# 18Z-011

# STAFF REPORT

7627 Stewart Road

**VARIANCE REQUEST:**

A0.01

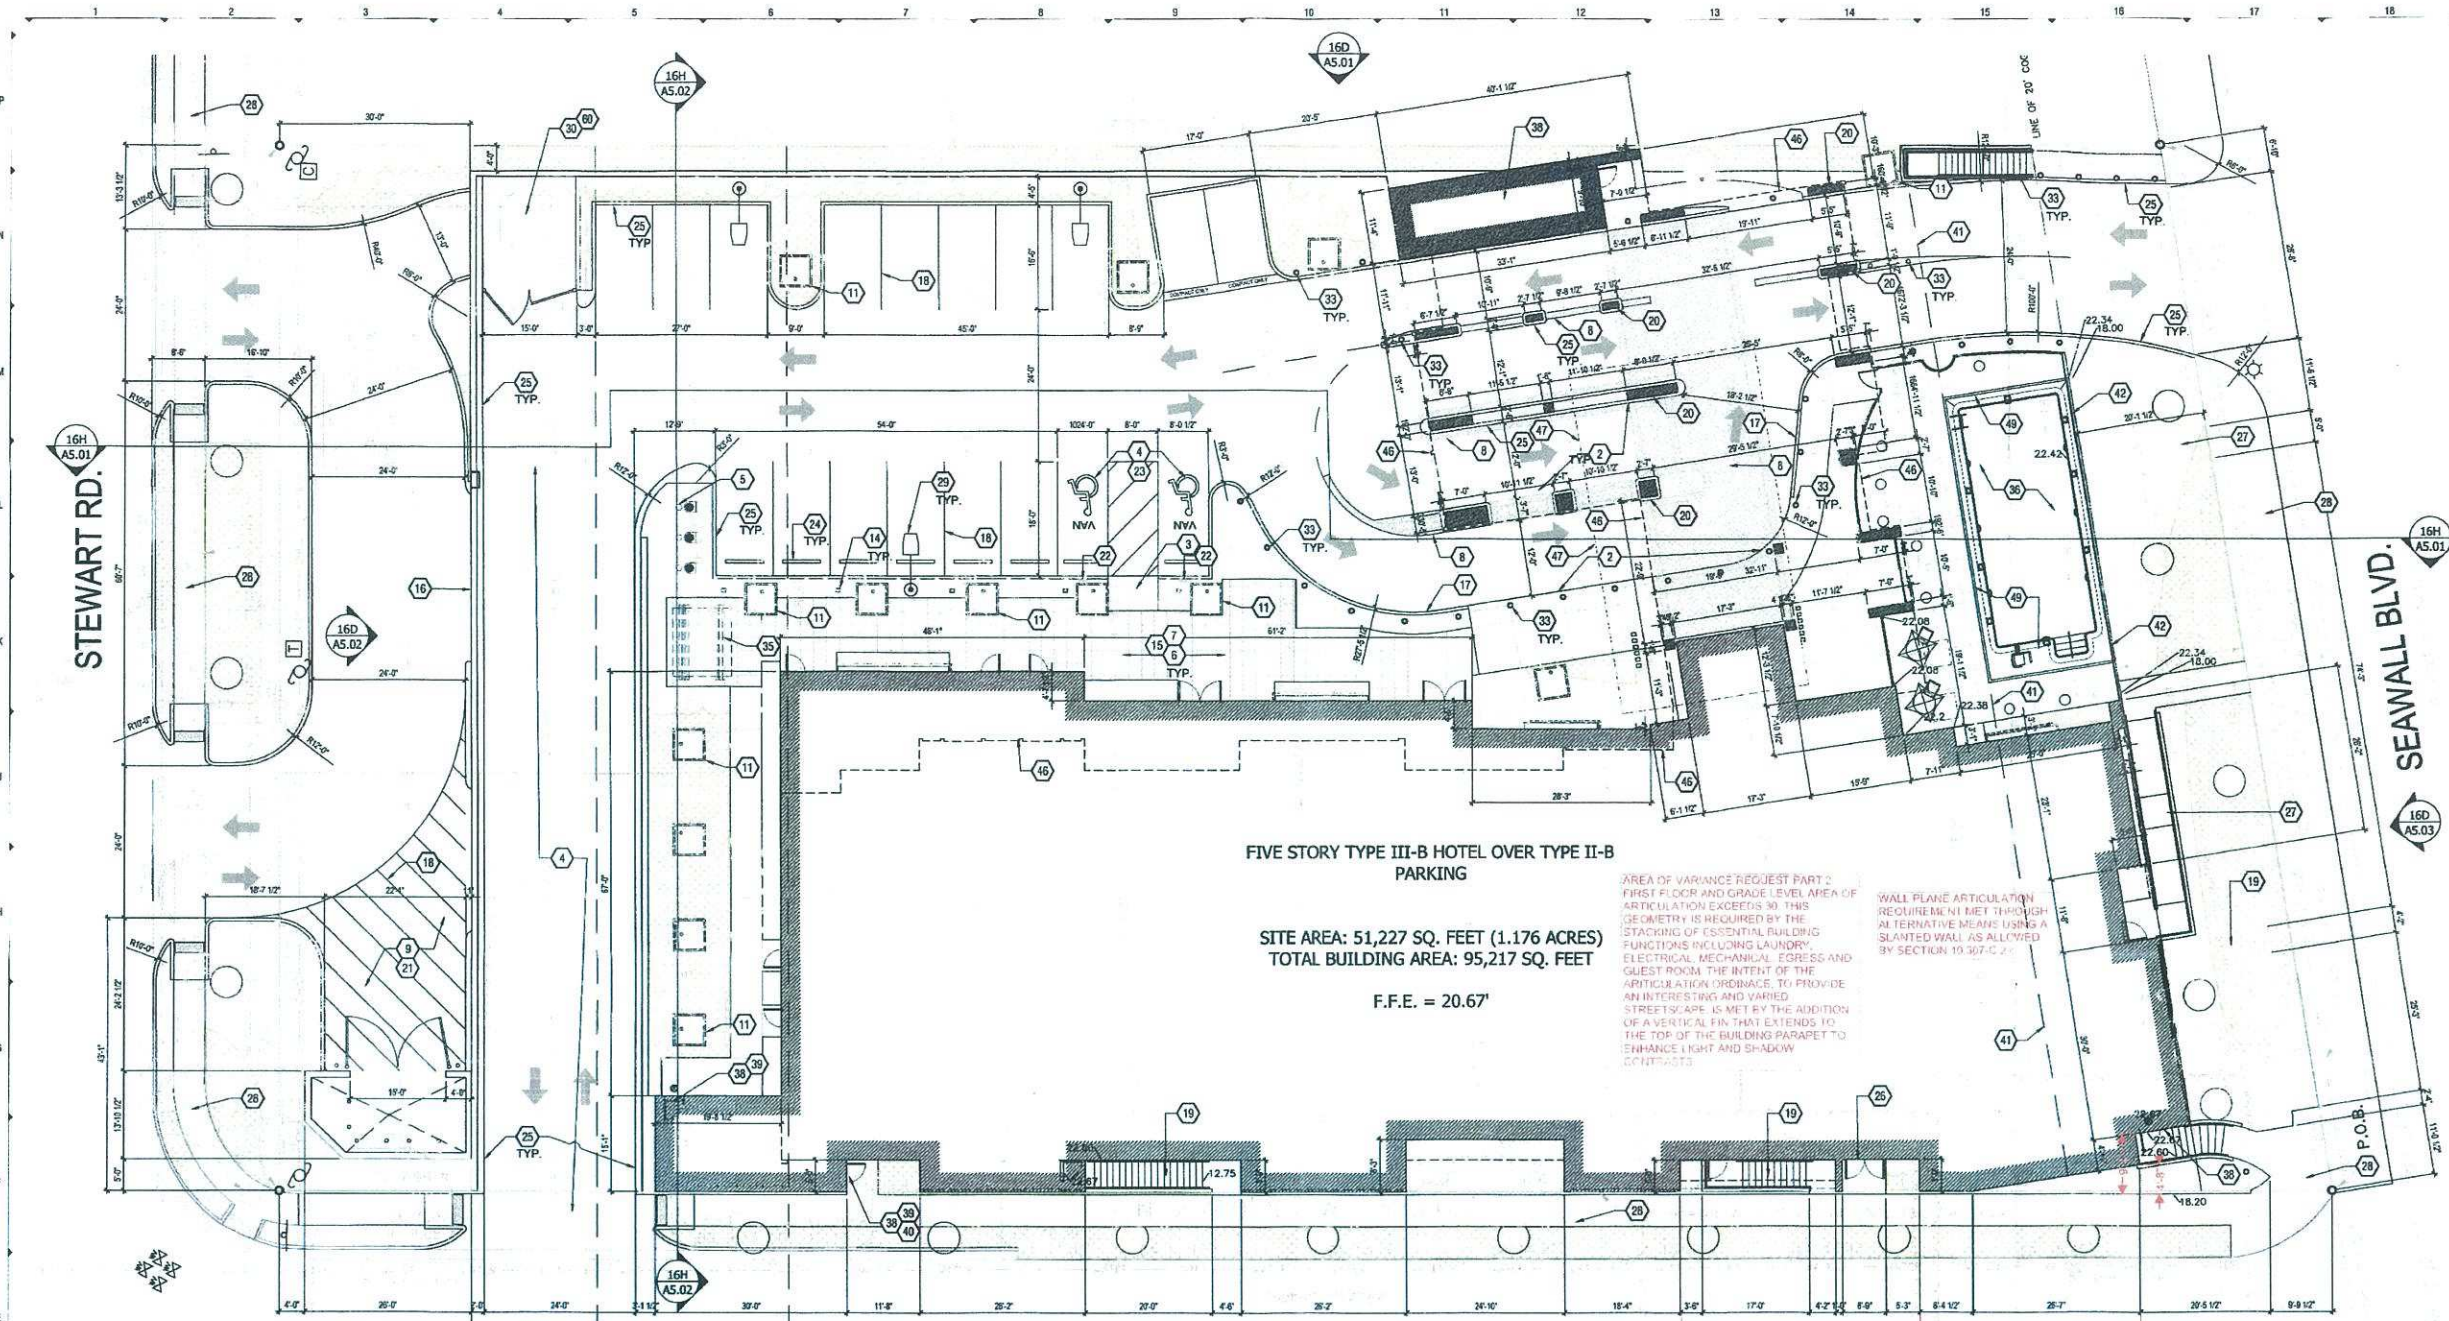
**Summary:** The applicant is requesting a variance from Wall Plane Articulation in two places on the west side of the proposed hotel. The two places that will not meet the Building wall Length maximum of 30-feet are side by side with a maximum wall space of 37-feet, 8-inches. Reference Exhibit B page A0.01.

**Requested Variance:** Wall Plane Articulation (Building Wall Length) – From 30-feet to 37-feet, 8- inches.

The applicant has exceeded the 75% maximum total for impervious cover allowed in Seawall West character area. The applicant is requesting to increase the maximum by 14%.

Lot Coverage Maximum– From 75% to 89%

AREA OF VARIANCE REQUEST PART 2: ARTICULATION EXCEEDS 30% THIS IS COMPLETED BY THE STACKING OF ESSENTIAL BUILDING FUNCTIONS INCLUDING LAUNDRY, ELECTRICAL, MECHANICAL, EGRESS AND GUEST ROOM THE INTENT OF THE ARTICULATION REQUIREMENT TO PROVIDE AN INTERESTING AND VARIED STREETSCAPE IS MET BY THE ADDITION OF A VERTICAL FIN THAT EXTENDS TO THE TOP OF THE BUILDING PARAPET TO CHANGE LIGHT AND SHADOW CONTRASTS

WALL PLANE ARTICULATION REQUIREMENT MET THROUGH AN ALTERNATIVE MEANS USING A SLANTED WALL AS ALLOWED BY SECTION 19.07.02.01

- 3. Variance Request Three. Lot Coverage**, by definition (Section 10.303-K), is the total area of all impervious structures or pavements on the site. Per Table 10.311 this is limited to 75% of the total site area. To get the maximum possible guest room count while complying with the Off-Street Parking requirements of this Use, vehicle ingress, egress and circulation, and while providing richly landscaped interior courts and amenities, we have ended up with 89% impervious area. We are proposing to mitigate this overage by providing 9,250 square feet of planted roof area, which will count for 6,938 square feet of additional impervious area (75% of 9,250) which brings the site into compliance at 75%. Please review the calculation in the Table, Drawing A7 on Sheet A0.01 for our design basis.

**A5.02**

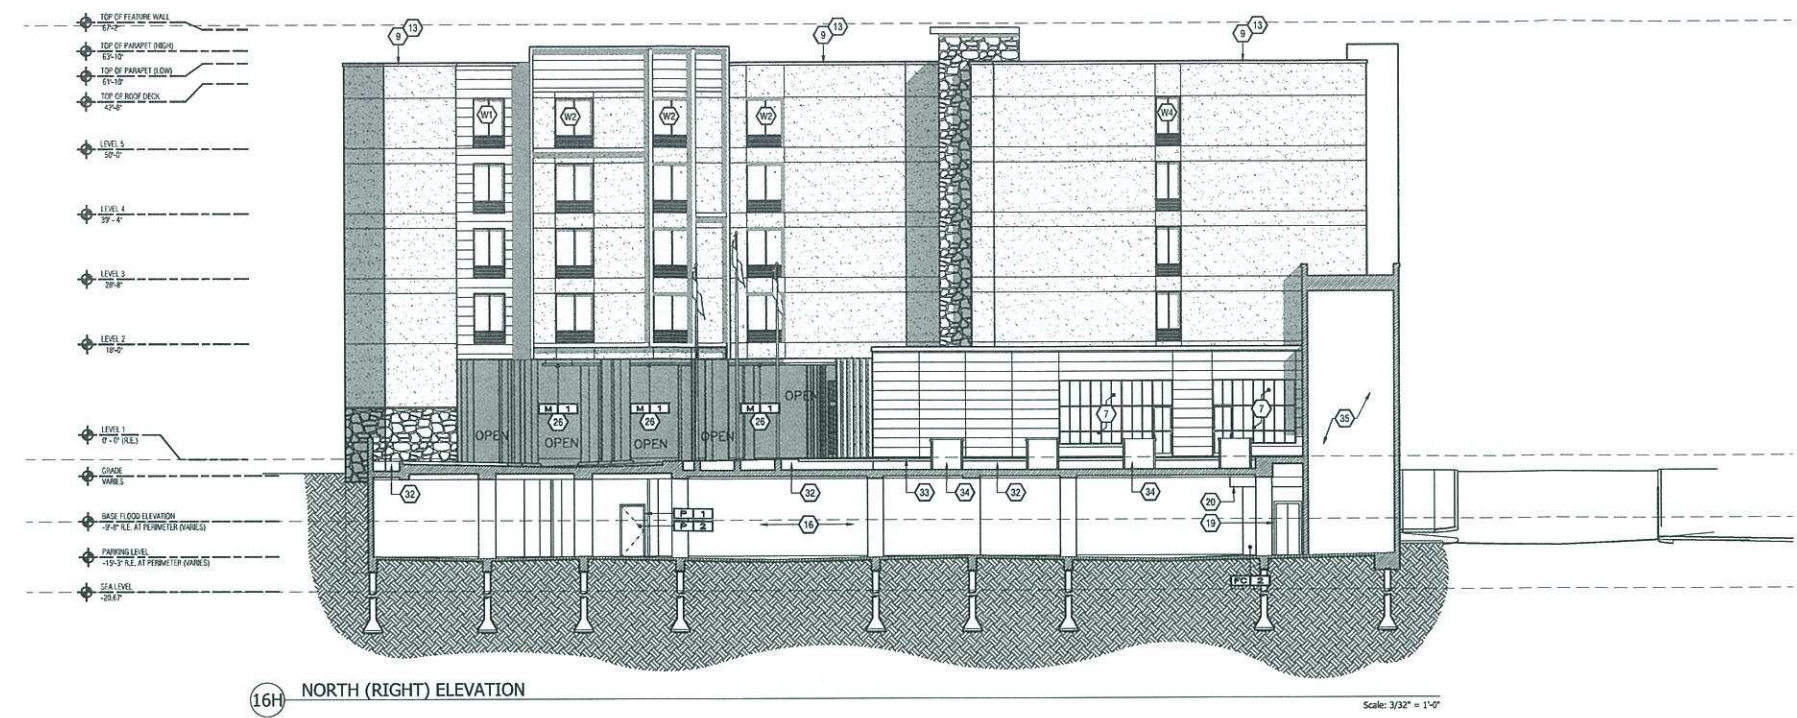
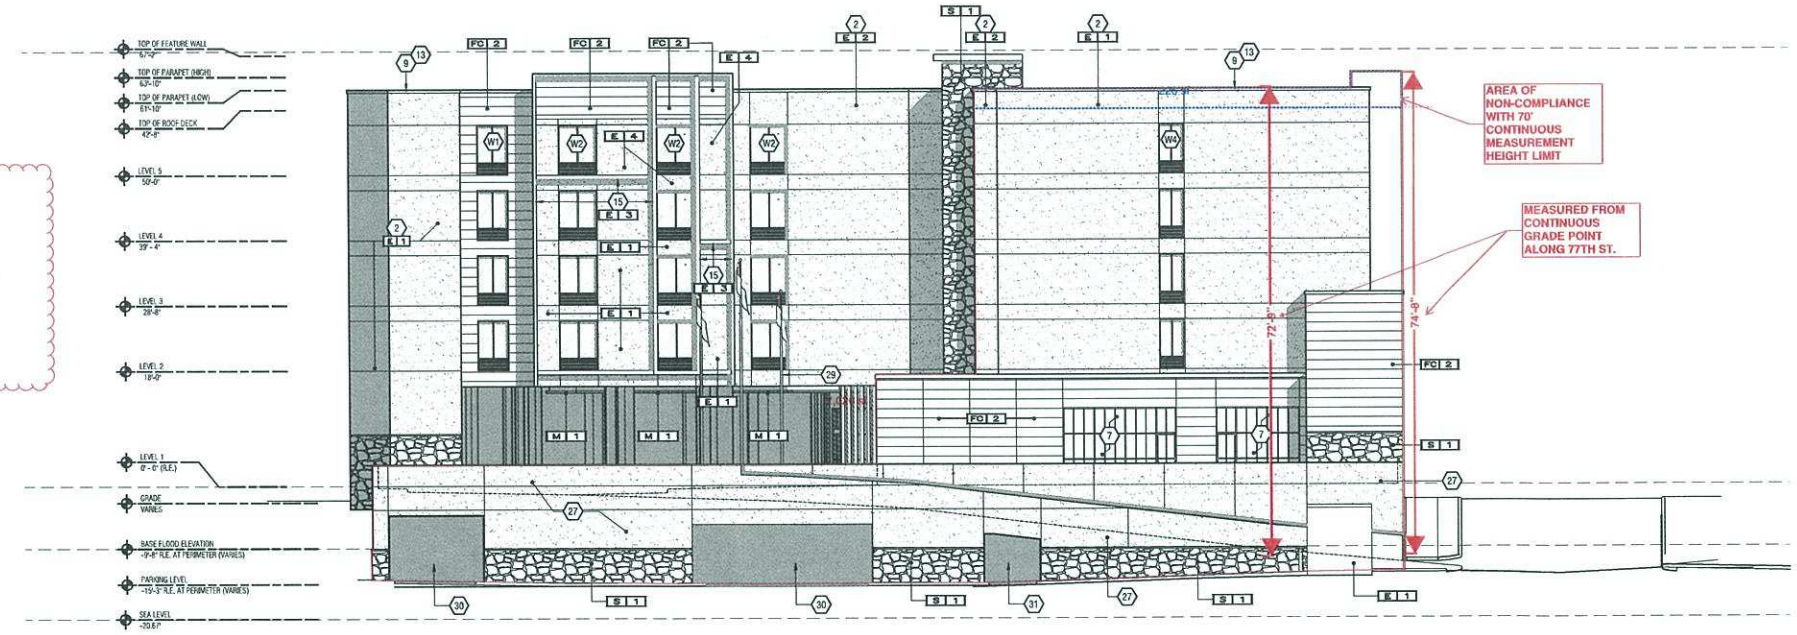
**Summary:** The applicant is requesting a variance from height along the north and west sides of the proposed Hotel shown in Exhibit B pages A5.02 and A5.03. The red arrows indicate the height in specific areas along those sides of the hotel due to the grade change. The highest point of the building is proposed to be 74-feet, 8-inches from grade.

**Requested Variance:** Height - From 70-feet to 74-feet 8-inches

**CONTINUOUS HEIGHT COMPLIANCE ANALYSIS:**  
TOTAL AREA OF THIS ELEVATION (IMPACTED PLANES) = 7,020 SQ. FT.  
AREA EXCEEDING 70 CONTINUOUS MEASUREMENT LIMIT = 226 SQ. FT.  
COMPLIANT AREA = 96.8%  
NON COMPLIANT AREA = 3.2%

1. **Variance Request One. Continuous Measurement Standard, Section 10.303-I.** This standard states that the maximum height for the building shall be measured continuously from existing or finished grade. We are requesting a variance from this standard along parts of the West (77<sup>th</sup> St.) elevation and parts of the North (Stewart) elevation. Specifically, referring to drawing sheet A5.03, we propose that 246 square feet of the total 16,249 square feet-- 1.5% of the West elevation--be allowed to exceed the continuous measurement standard by less than four feet at its worst condition. Additionally, referring to drawing sheet A5.02, we have 226 square

feet of the total 7,020 square foot far North elevation that exceeds this standard (3.2%). We believe that the other elevations comply with the standards as designed.
